# Yell County Wildlife Federation

I am contacting you seeking information about NRC's current regulatory nuclear powerplant safety guidance your Agency may have regarding construction of new regional airports within the 10 mile Emergency Planning Zone and affects such a large airport may impose upon renewal of nuclear plant licensing. NRC is currently soliciting public Scoping comments until May 9 for developing an Environmental Impact Statement on a proposed extension of the Arkansas Nuclear One Operating License.

The City of Russellville is currently pursuing construction of a large Regional Airport with a 10,000 foot runway as depicted in the enclosed drawing. The proposed recycled site is near the same location that NRC and the Environmental Protection Agency objected to in 1980 due to large type jet aircraft potential interference and adverse impacts upon nearby Galla Creek Wildlife Management Area, Holla Bend National Wildlife Refuge and safety risk these heavy aircraft would impose upon Arkansas Nuclear One.

Figure D4 Proposed Airport Site Layout

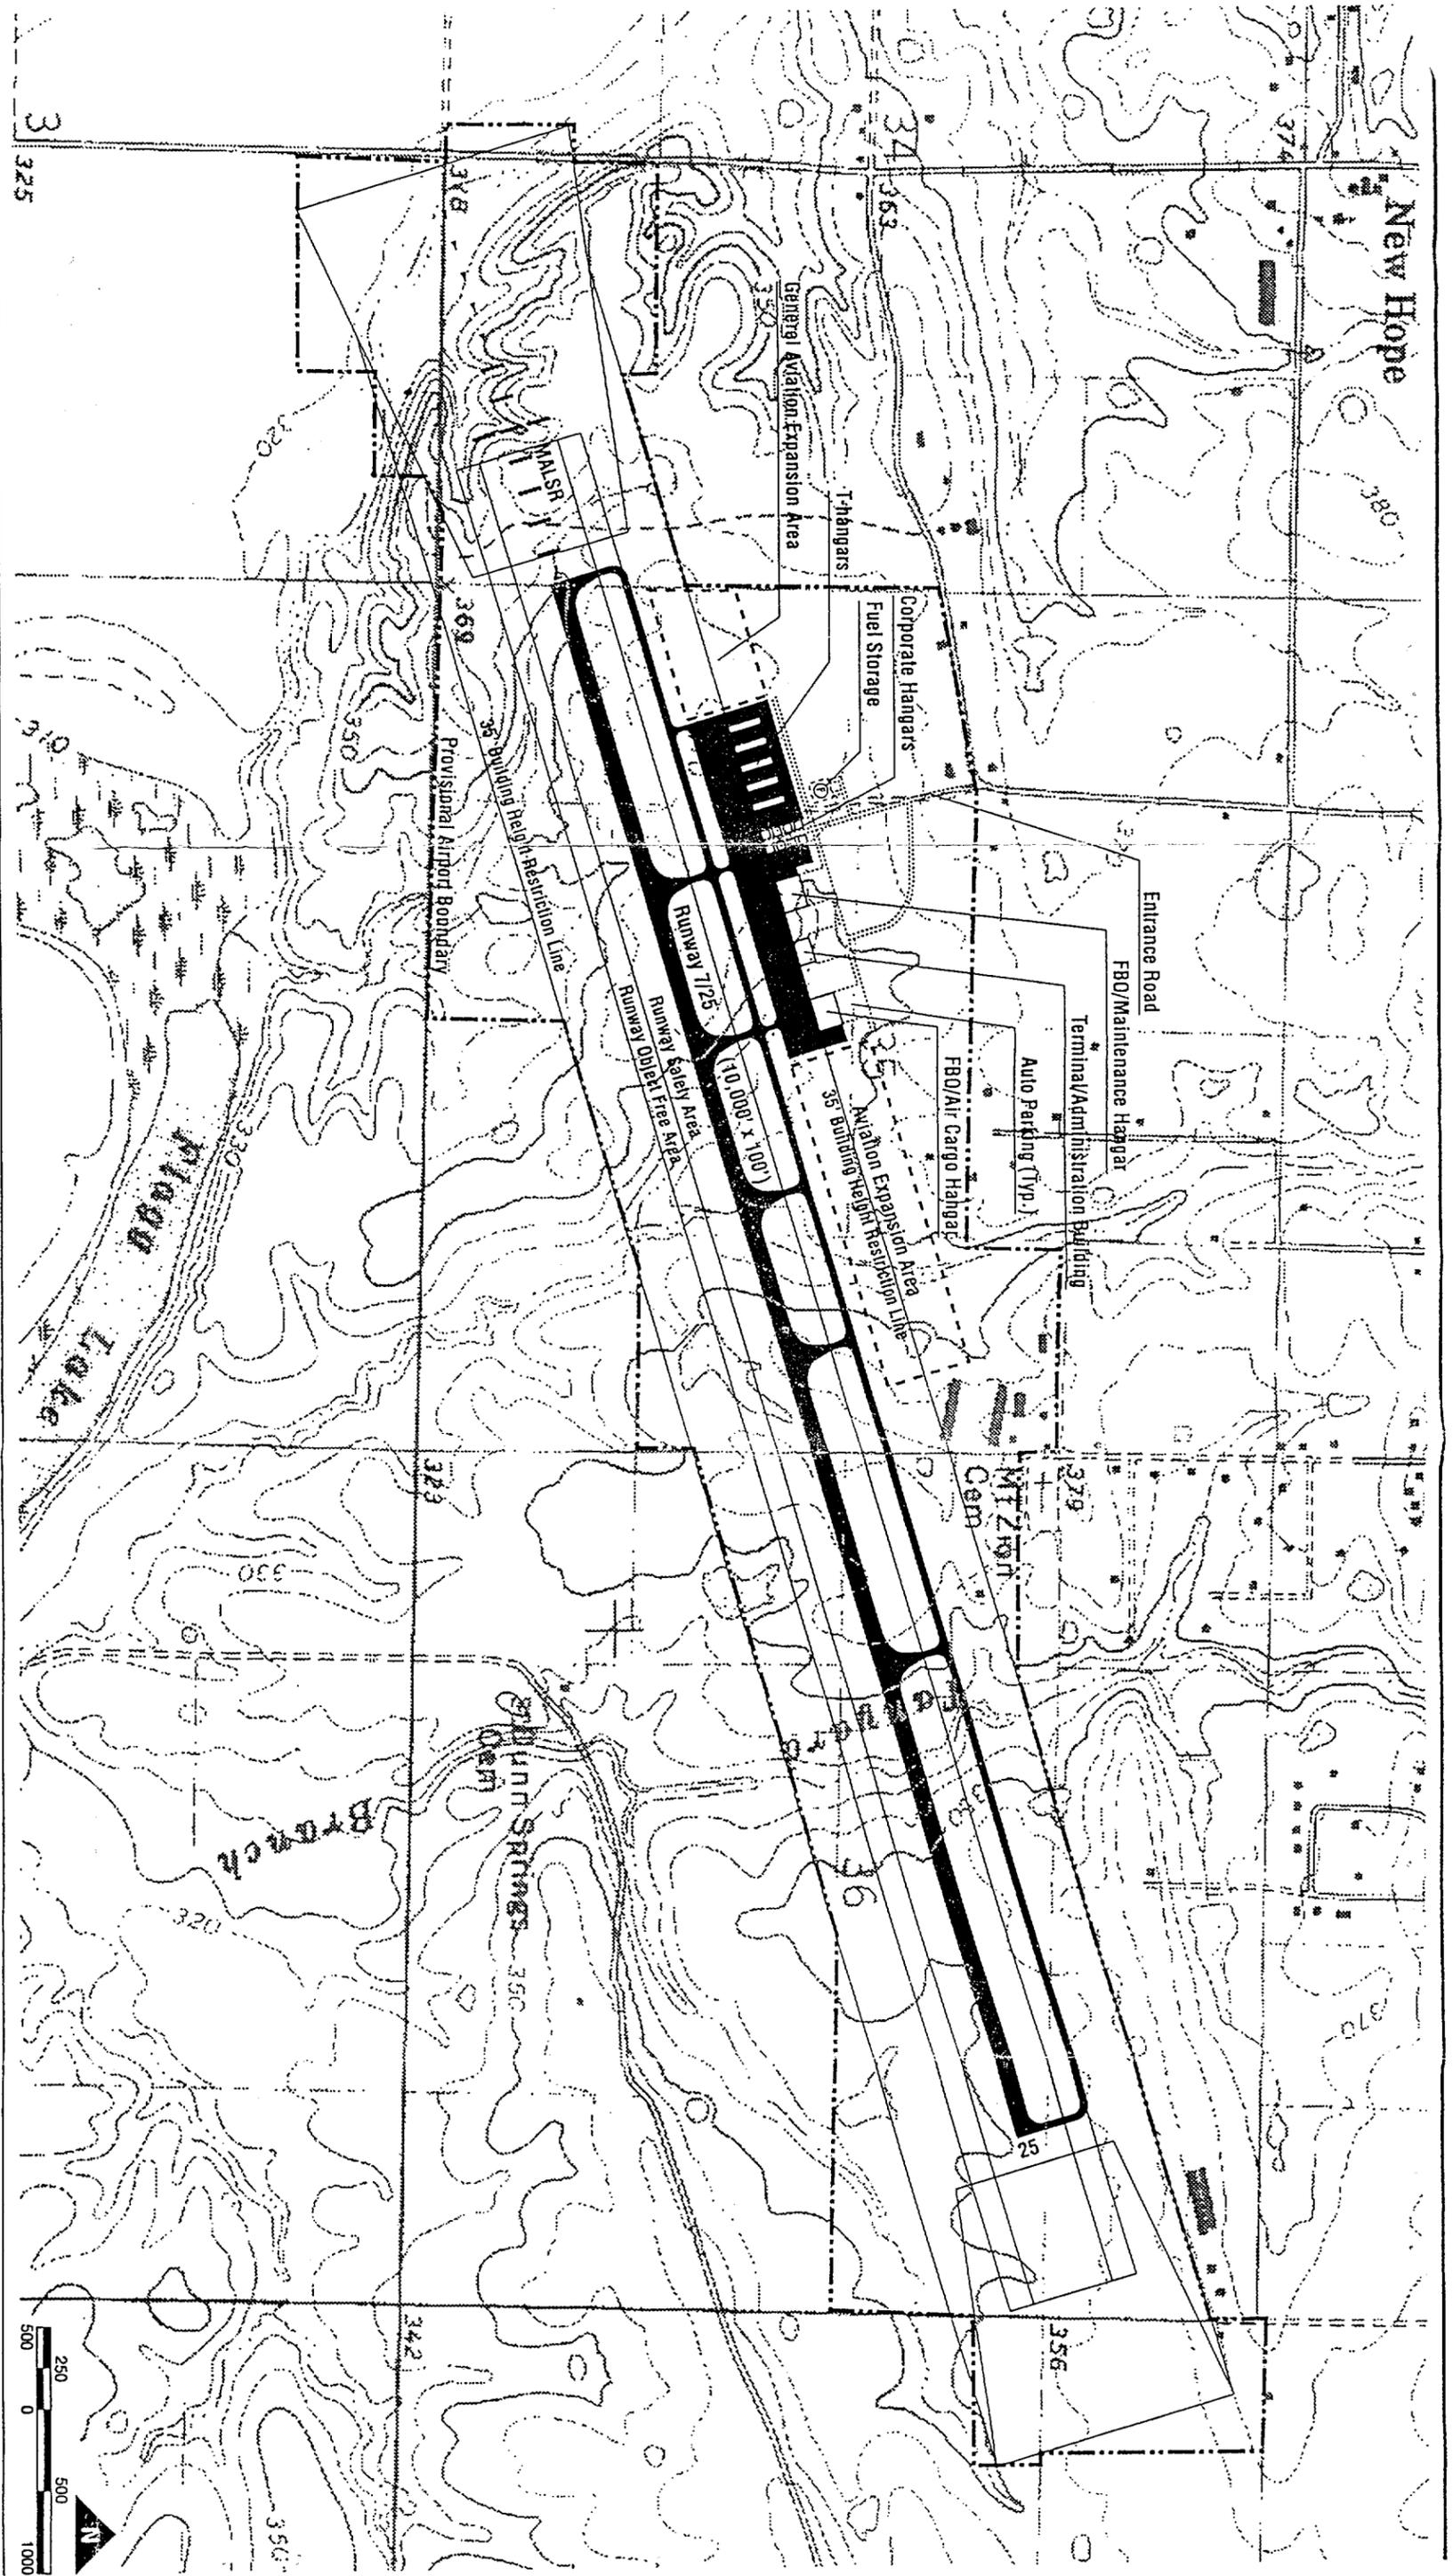
Since the 1980 airport site denial by FAA, NRC has established a 10 mile Emergency Planning Zone (EPZ) around this nuclear plant. To build a regional airport at the proposed site will create heavy jet type aircraft activity within the EPZ and would seem to be an unacceptable risk to local community health and safety, in no less measure than the similar project presented in 1980. There is tremendous wintering waterfowl activity between Holla Bend Refuge and Lake Dardanelle, as far upstream as Ark. Nuclear One.
